## Planning Commission Staff Report

**Project type:** Amended Architectural Elevations

**Description:** Chesterfield Outlets (The District) 8<sup>th</sup> AAE: Amended Architectural Elevations for a 48.15 acre site within the “PC” Planned Commercial District located north of N Outer 40 Road and east of Boone’s Crossing. (17T420027)

Figure 3: Proposed Wall Graphics

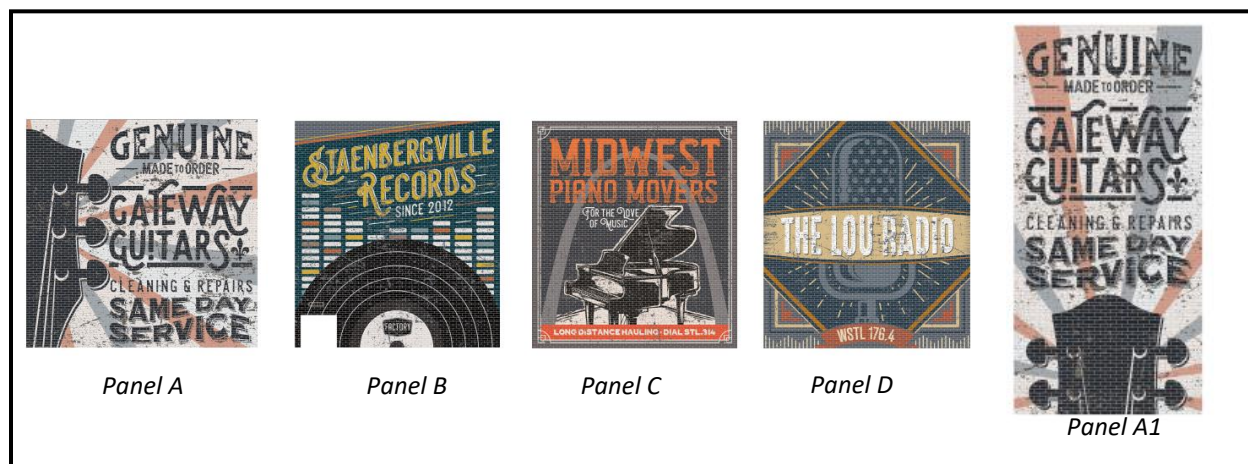
The proposed graphics are comprised of paint applied to the existing thin brick veneer. The application of the paint will be muted and distressed, and the colors in the graphics are similar to those used throughout the development.

There are seven proposed graphics in total – three (3) will be located on the east elevation, and four (4) will be located on the west elevation (Figure 3). The proposed graphics are comprised of paint applied to the existing thin brick veneer (Figure 4). The application of the paint will be muted and distressed, and the colors are similar to those used throughout the development. The applicant has provided a brief narrative explaining the rationale behind the proposed graphics and how they further the vintage industrial architectural style. Also provided in the ARB packet is a full list of materials and colors for each elevation of The Factory.

On December 10<sup>th</sup>, 2020 this application was reviewed by the City of Chesterfield's Architectural Review Board. At that time, the Board made a motion to recommend approval as submitted.

Staff has reviewed the Amended Architectural Elevations for Chesterfield Outlets (The District) and there are no outstanding issues on this request. Staff requests action from the Planning Commission.

Figure 4: Locations of Proposed Wall Graphics

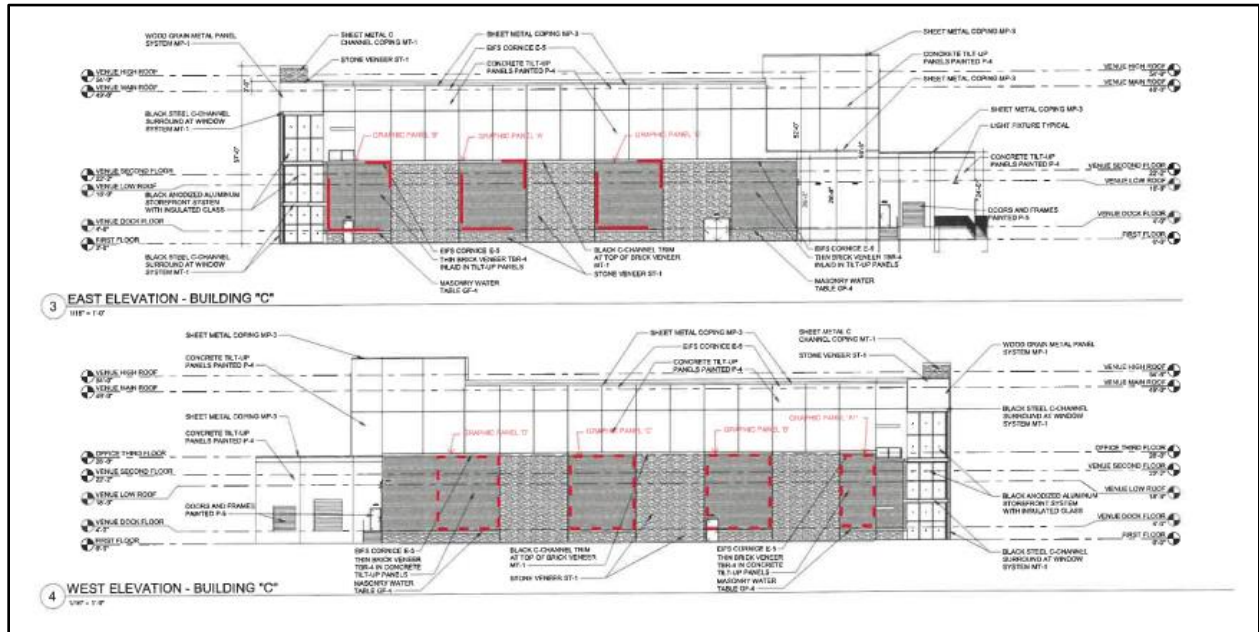
The applicant is proposing that the painted graphics be located on the east and west elevations of The Factory. It should be noted that the graphics on the west elevation will be highly visible from the entrance into the development and from off-site, particularly from the Monarch Chesterfield Levee Trail and North Outer 40 Road.

Sheet Name: GRAPHIC PANELS

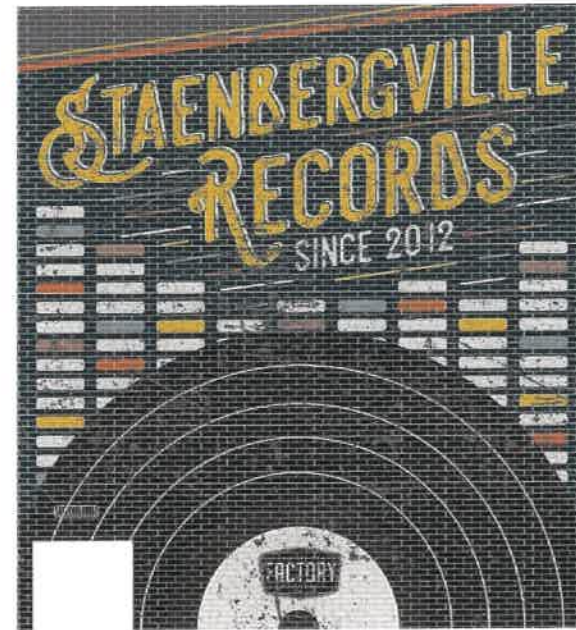
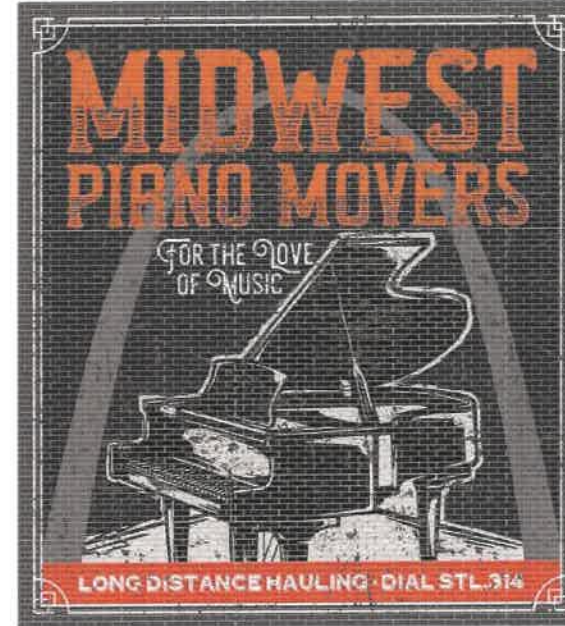
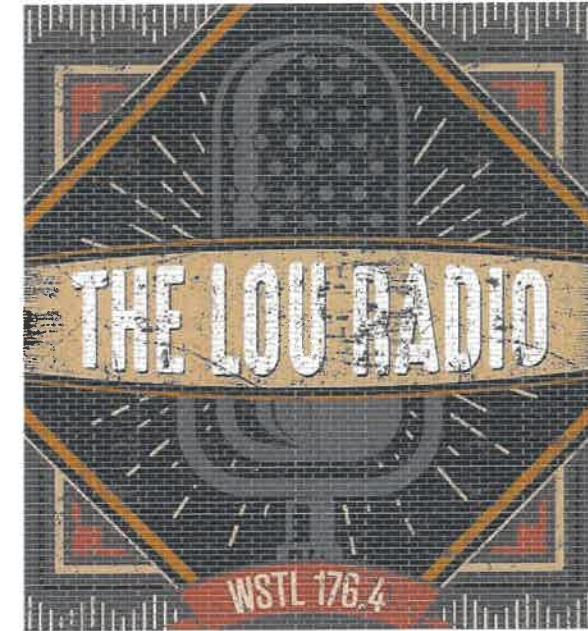
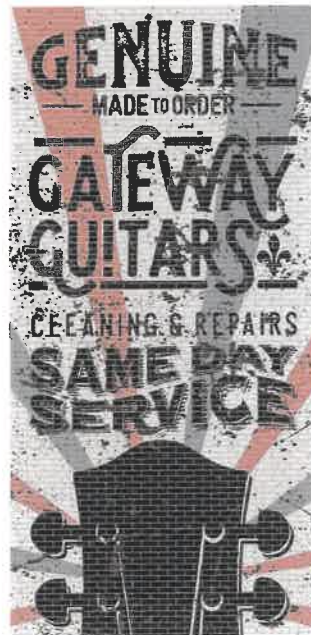
GRAPHICS TO BE PAINTED OVER THE THE BRICK VENEER ON THE EAST AND WEST SIDE OF BUILDING "C".
